1. **RICHMOND ZONING BYLAW 8500, AMENDMENT BYLAW 10120 (RZ 19-858458)**  
(File Ref. No. (RZ 19-858458) (REDMS No. 6351904))

## Report to Committee

**Re:** Application by Benn Panesar for Rezoning at 10931 Seaward Gate from the  
"Single Detached (RS1/E)" zone to the "Compact Single Detached (RC2)" zone

Attachment 5: Tree Management Plan

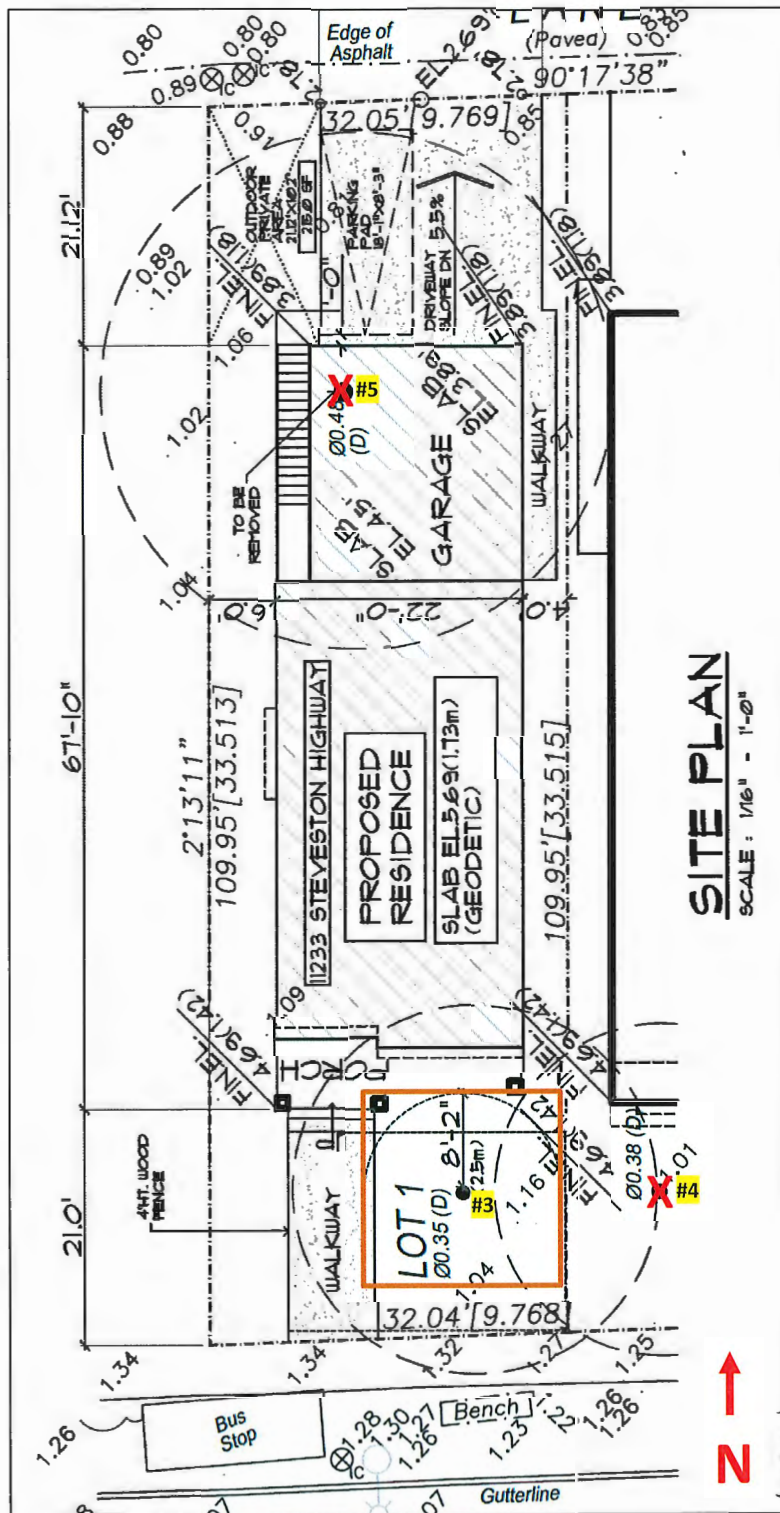
The City's Tree Preservation Coordinator has reviewed the Arborist's Report and concurs with the Arborist's findings, with the following comments:

- One tree (tag # 3) is a mature pear tree in fair-good condition and is located outside the proposed building envelope. Retain and protect as per City of Richmond Tree Protection Information Bulletin Tree-03.
- One tree (tag # 4) is a mature plum tree in poor condition and is located outside the proposed building envelope. Staff inspected the tree and confirmed winter shoot moth damage to the canopy and black knot in the upper branches which would limit the long term viability of the tree. Remove and replace.
- One tree (tag # 5) is a mature cherry tree in good condition. This tree will be in direct conflict with the proposed dwelling. Remove and replace.
- Replacement trees should be specified at 2:1 as per the OCP.

- Two hedges (tag # 1 and 2) located on City property are in fair condition and good health. The hedges have been left to grow without maintenance, and invasive weeds are starting to overtake the hedges. Due to conflicts with the construction of the frontage improvements, removal is recommended. Compensation is not required for the hedges.

One tree (tag # 3) is to be retained and protected. The applicant has submitted a Tree Management Plan showing the tree to be retained and the measures taken to protect it during development stage (Attachment 5). To ensure that the tree identified for retention is protected at development stage, the applicant is required to complete the following:

- No grade changes are to occur within the tree protection zone. For this reason, the applicant is required to construct a floating porch (i.e., no concrete foundation within the tree protection zone) and a cantilevered second floor balcony, as shown in the conceptual plans provided in Attachment 6.

- Prior to final adoption of the rezoning bylaw or demolition of the existing dwelling, whichever is first, submission of a Tree Survival Security to the City in the amount of \$10,000 for the one tree to be retained.

The applicant wishes to remove two on-site trees (tag # 4 and 5). The 2:1 replacement ratio would require a total of four replacement trees. Consistent with the landscaping requirements contained in Richmond Zoning Bylaw 8500 and the Arterial Road Land Use Policy, the applicant has proposed to plant four replacement trees in the development; one on proposed Lot 1 and three on proposed Lot 2 (corner lot).

Attachment 6: Conceptual Floor Plans and Building Elevations

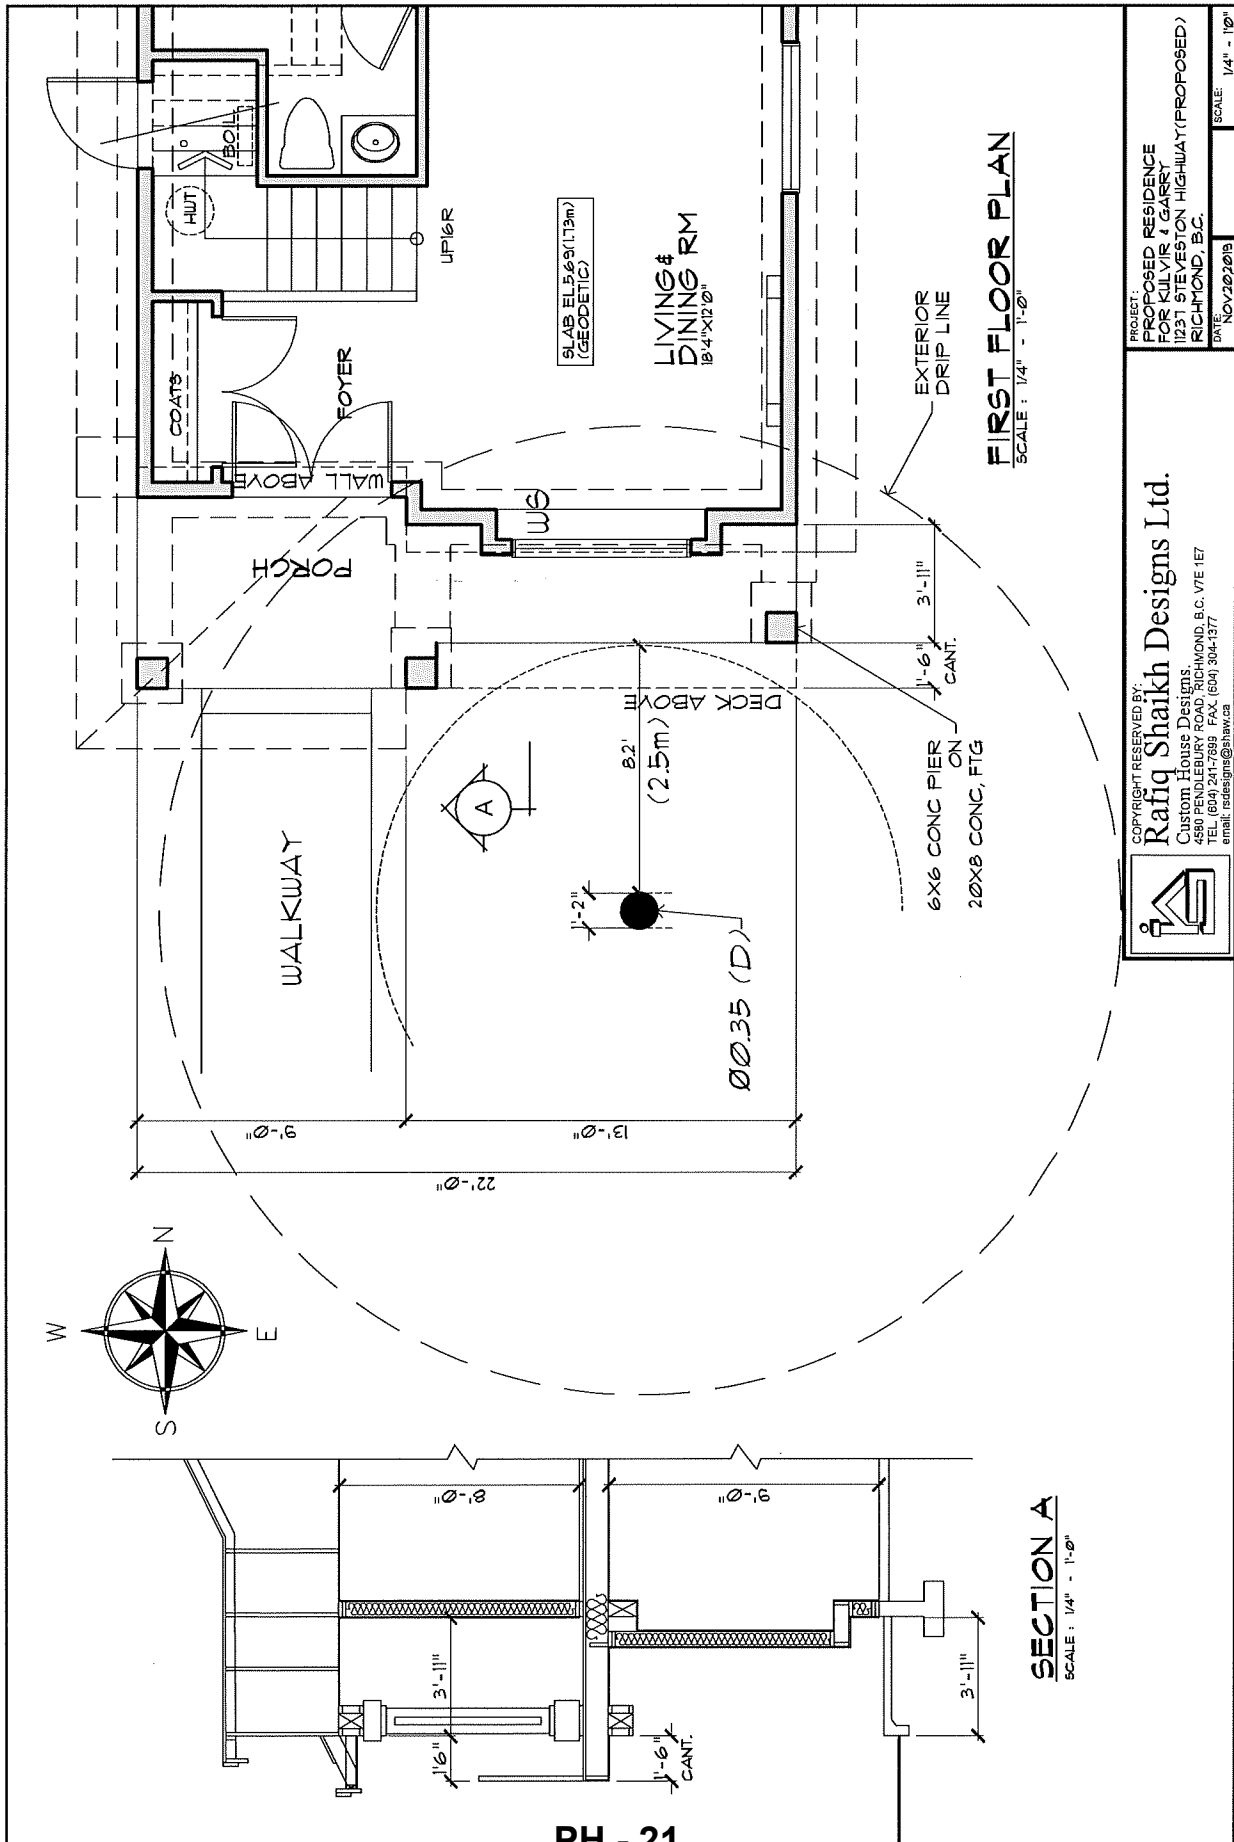
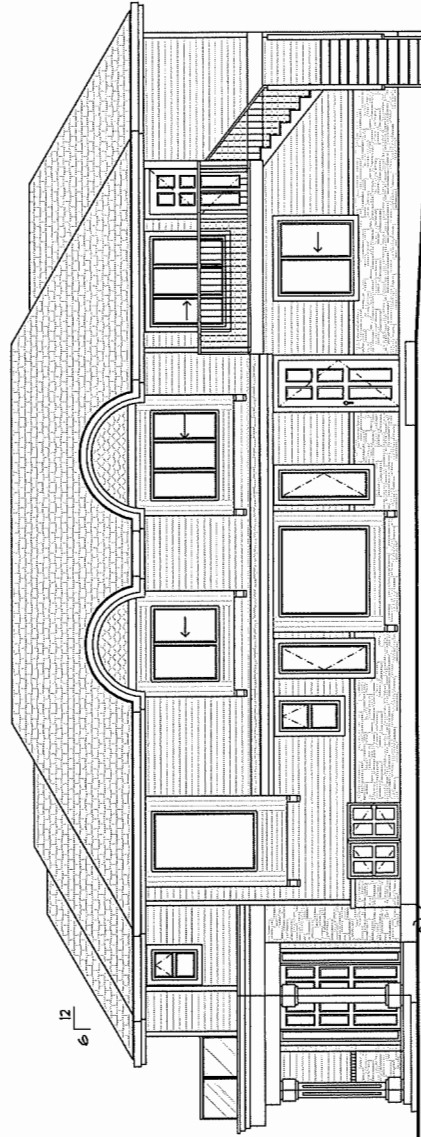
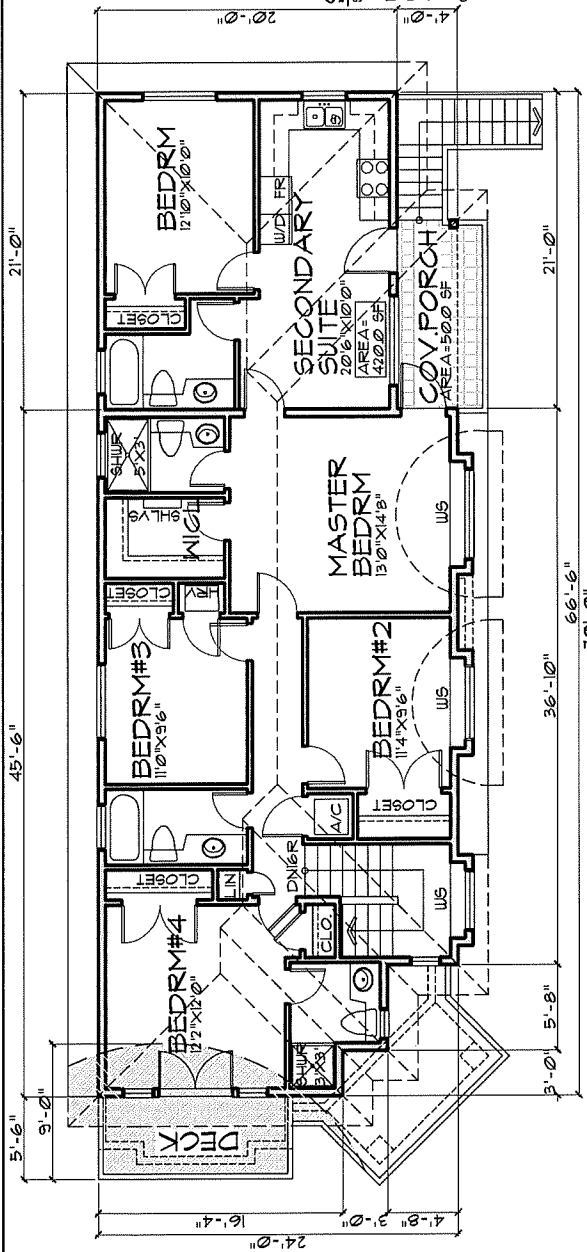
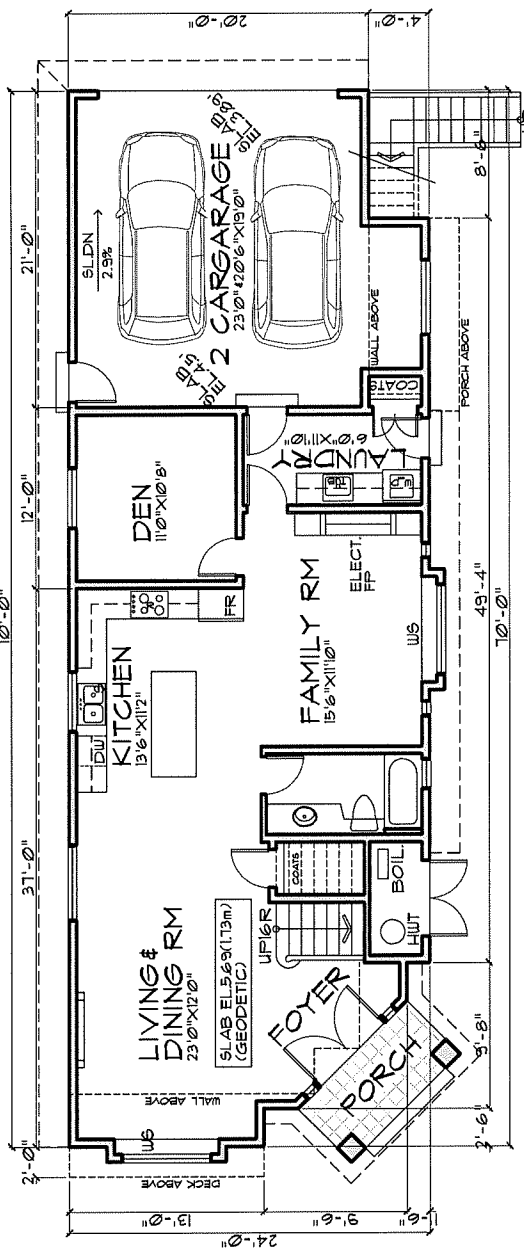
The applicant has submitted conceptual plans showing the proposed floor plans and architectural elevations for the proposed building on each proposed lot to demonstrate tree retention and the design of the corner lot dwelling (proposed Lot 2) at the intersection of Steveston Highway and Seaward Gate (Attachment 6).

The applicant has proposed a secondary suite on top of the attached garage on the second floor of each dwelling, each with a covered porch facing the side yard and direct access to the yard via exterior stairs. The front entrance to the principal dwelling on the corner lot (proposed Lot 2) is proposed to be on an angle to address both Steveston Highway and Seaward Gate.

Prior to final adoption of the rezoning bylaw, the applicant is required to register a legal agreement on Title to ensure that the Building Permit application and ensuing development of both lots are consistent with the submitted conceptual plans (Attachment 6), to the satisfaction of the Director of Development. Building Permit plans must comply with all City regulations and staff will ensure that the plans are generally consistent with the registered legal agreement.
